**Subject: TECHNICAL BULLETIN ISTB-2020-03**

**Revisions to *City of Ottawa Accessibility Design Standards, Second Edition* dated November 2015**

**TECHNICAL BULLETIN ISTB-2020-03**

The document entitled *City of Ottawa Accessibility Design Standards, Version 2.0 dated November 2015* is amended by the addition of the enclosed new Appendix 7.8 entitled *Interim Guidance for Accessibility Measures in the Presence of Cycling Infrastructure*.

# Appendix 7.8A-2: Unconstrained\* (Option 2)

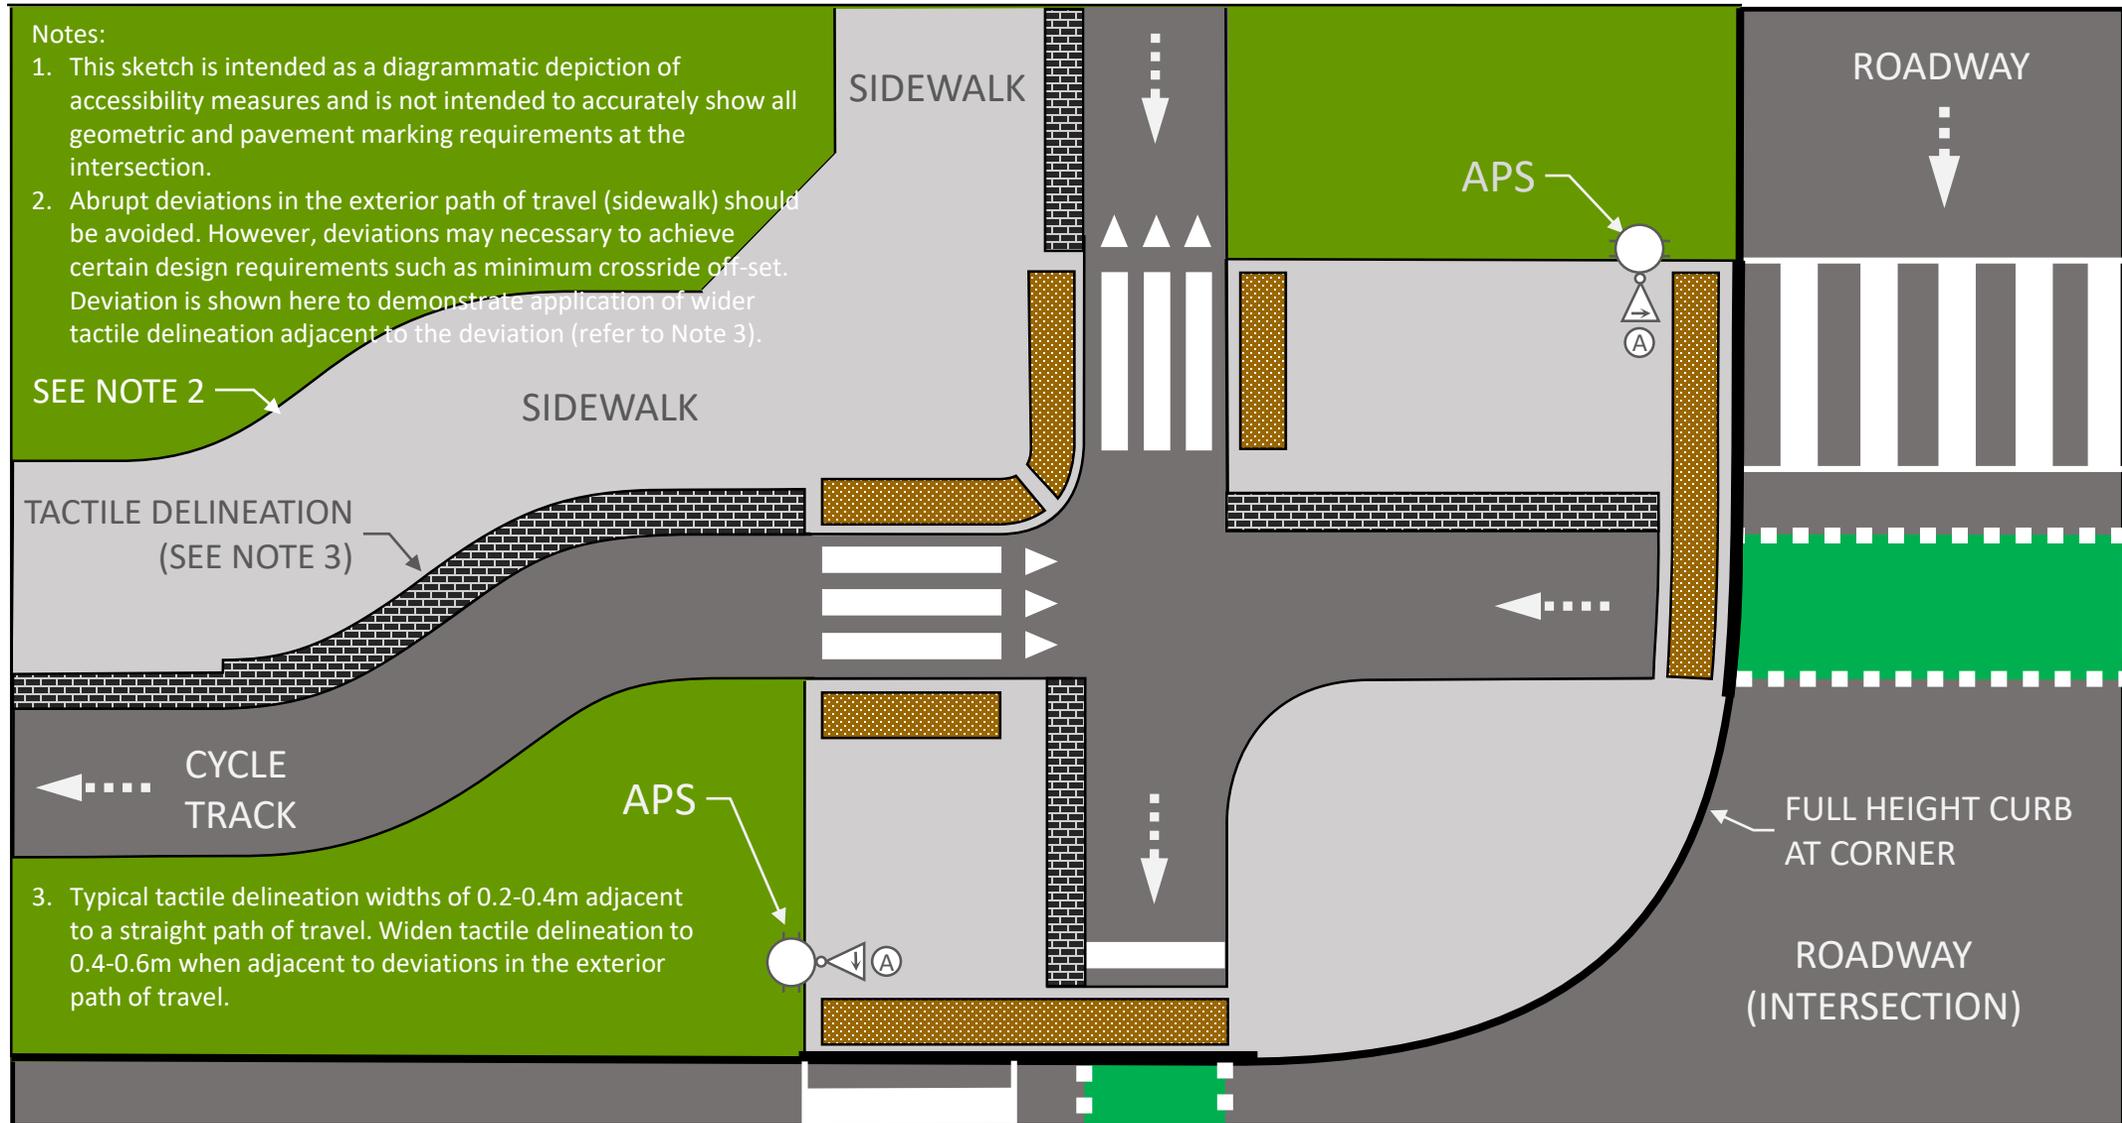
- An unconstrained protected intersection corner with straight pedestrian path of travel (Appendix 7.8A-1),
- An unconstrained protected intersection corner with a deviation in the pedestrian path of travel (Appendix 7.8A-2), and,
- A constrained protected intersection corner (Appendix 7.8A-3).

Note that the term “unconstrained” as used in the descriptions of the Appendix A7.8-1 and Appendix 7.8A-2 scenarios above refers to a corner with sufficient space at each pedestrian crossing to provide a pedestrian waiting area that is  $\geq 2.7\text{m}$  long (per current City of Ottawa practice) between the cycle track and the roadway edge. The term “unconstrained” does not literally mean the corner is completely free of all constraints.

# Appendix 7.8A-3: Constrained\*

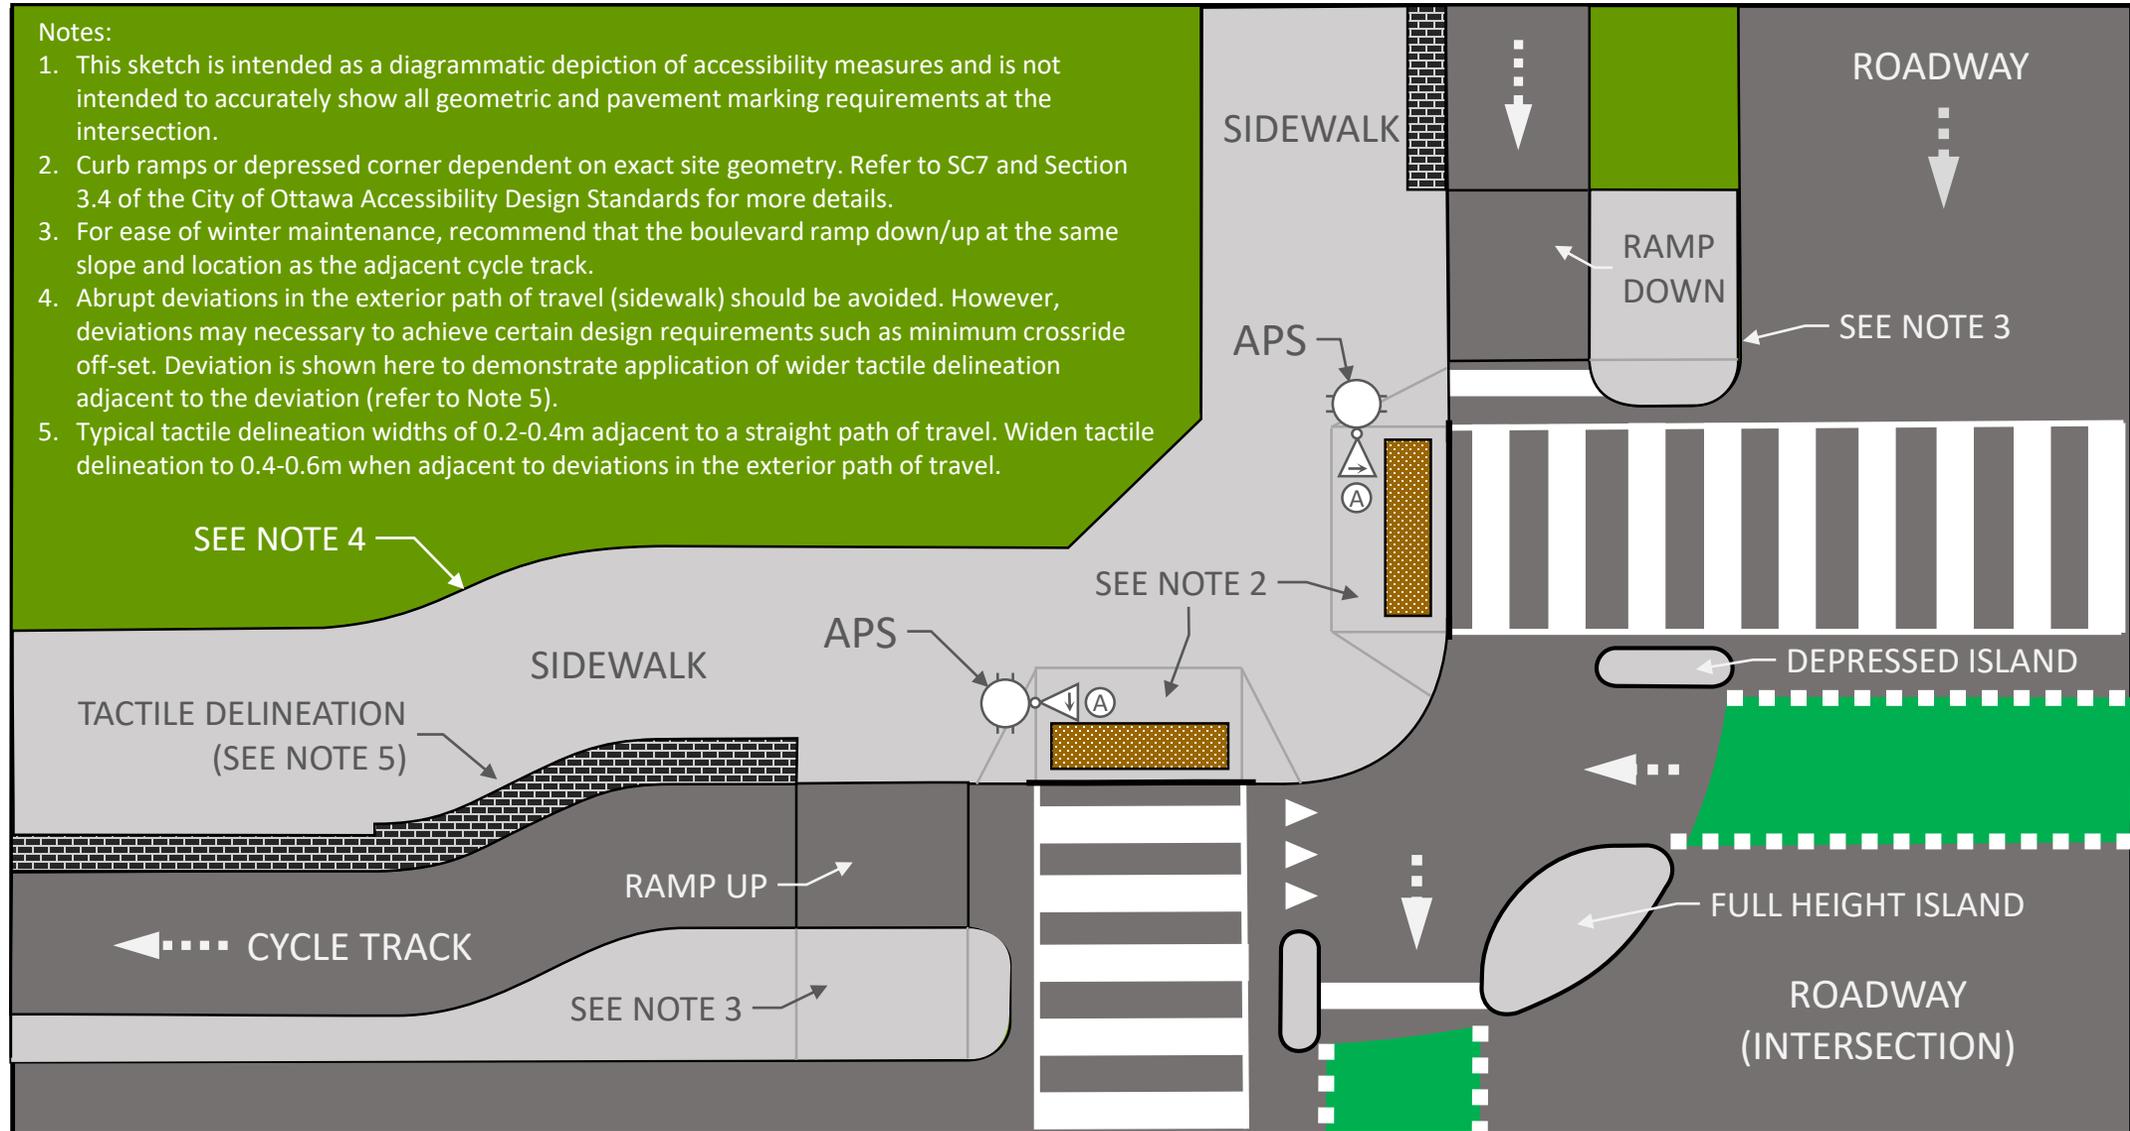
Conversely, the term “constrained” as used in the description of Appendix 7.8A-3 above refers to a corner that does not have sufficient space to provide a pedestrian waiting area that is  $\geq 2.7\text{m}$  long. The “constrained” design depicted in Appendix 7.8A-3 does not necessarily represent the maximum space constraints possible at a signalized protected intersection corner. It is up to the individual practitioner to apply the guidance provided within this document to constrained intersections and potentially consider other design alternatives (e.g. two-stage left-turn queue boxes) if space limitations prevent the implementation of a constrained protected intersection corner in an accessible manner.

# Appendix 7.8A-4: MUP Transition, Unconstrained\*

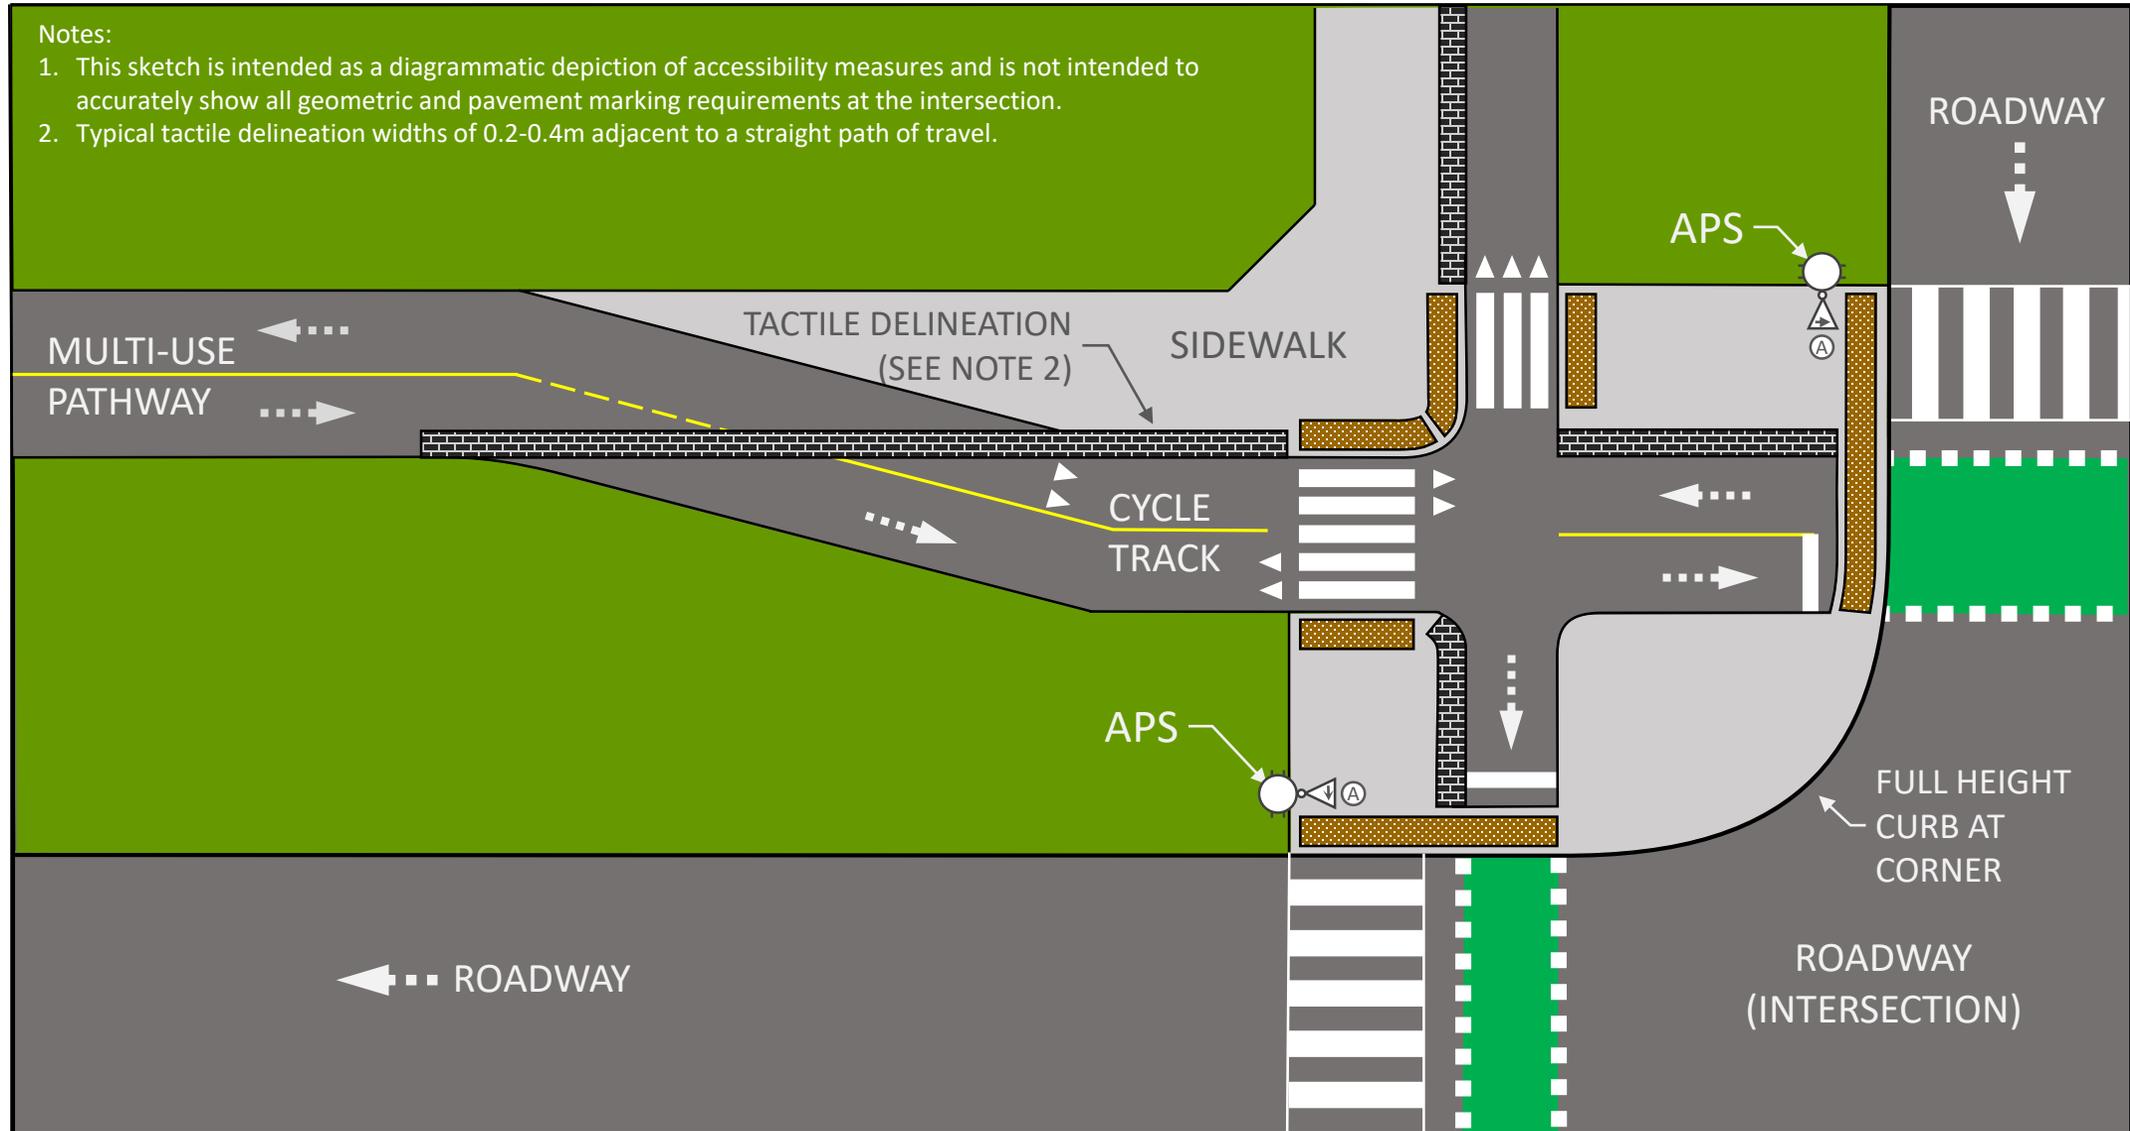
- An unconstrained scenario (Appendix 7.8A-4), and,
- a constrained scenario (Appendix 7.8A-5).

As previously mentioned, the term “unconstrained” is meant to refer to a corner with enough space at each pedestrian crossing to provide a pedestrian waiting area that is  $\geq 2.7\text{m}$  long between the cycle track and the roadway edge. While the term “constrained” is used to refer to a corner that does not have enough space to provide a pedestrian waiting area that is  $\geq 2.7\text{m}$  long.

# Appendix 7.8A-5: MUP Transition, Constrained\*

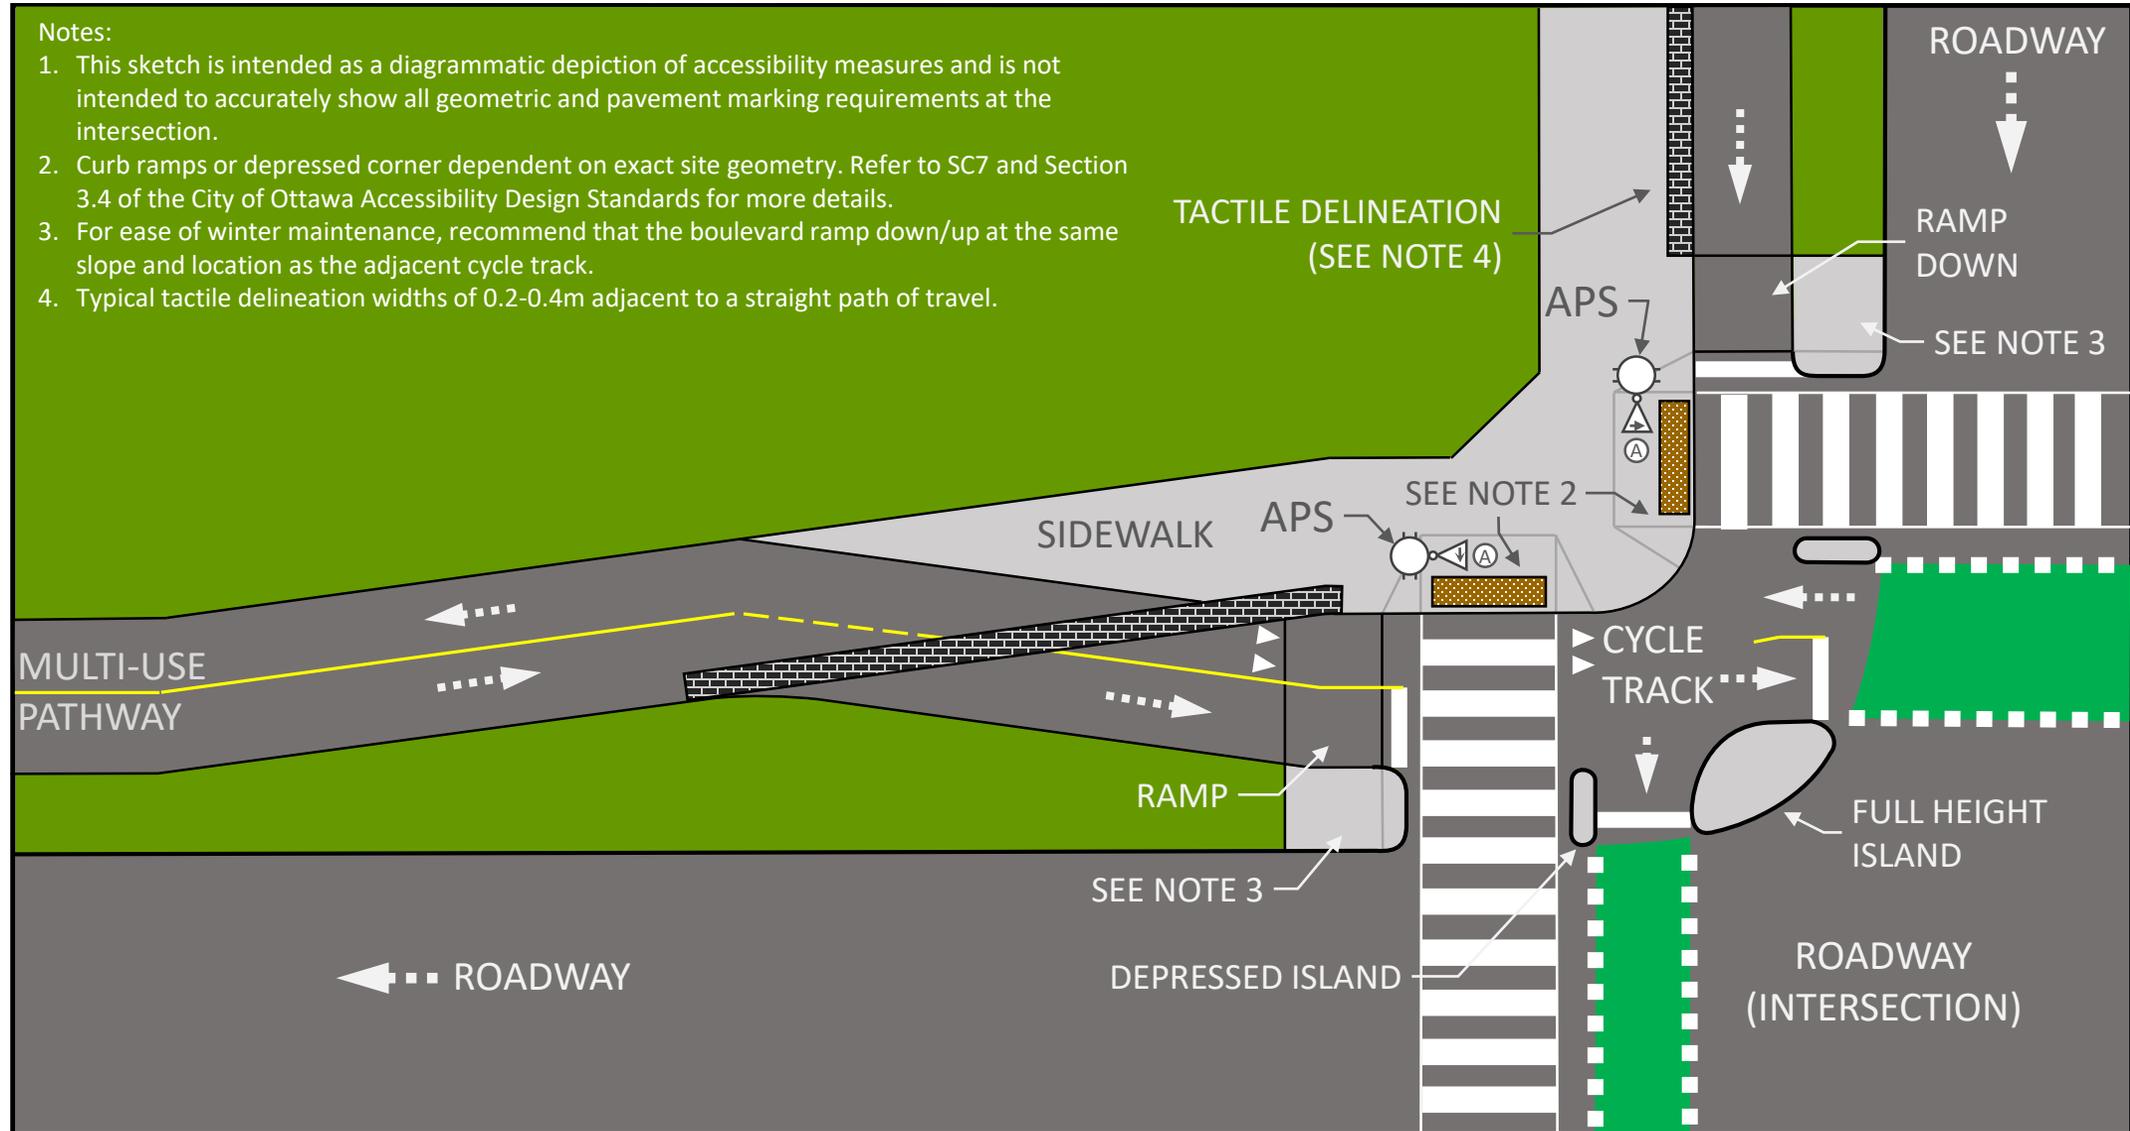
It is expected that, given the design features listed above (refer to Appendix 7.8A-3 and Appendix 7.8A-5 schematic examples), various contextual and detectable features (including the full-height curb that develops between the sidewalk and road-level cycle track, the adjacent pedestrian curb ramps or depressed corner, and the full-height corner island) will be sufficient to alert pedestrians with vision loss that they are walking within the cycle track before they reach the roadway.
